Ivilo Heights Subdivision Final Drainage Report

Colorado Springs, El Paso County, Colorado

January 2024

SHEET # **FIG.4**

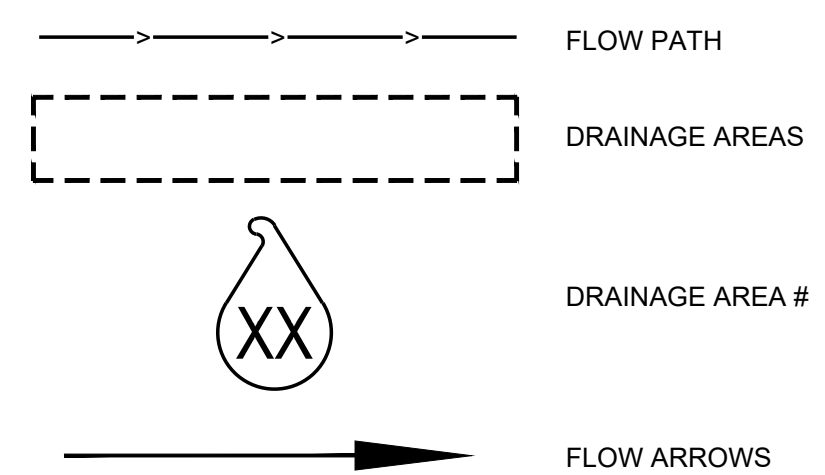
Please show and label existing and proposed contours in the legend.
